Economic Commission for Europe

Group of Experts on cycling infrastructure module

Cycling infrastructure definitions and standards

Possible modifications to 1968 Convention on Road Signs and Signals

DIAGRAMMATIC ADVANCE DIRECTION SIGN FOR CYCLISTS

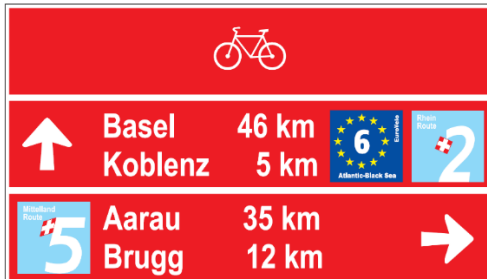
G, 2 d (G-02.4) notifies of advance directions applicable to cyclists only. This sign is an example of an advance direction sign (intersection).

An example of the road sign should be developed. The proposed solution to indicate the sign’s applicability to cyclists is presented below. The applicability to cyclists is denoted by placing the symbol of a cycle in the upper part of the sign.
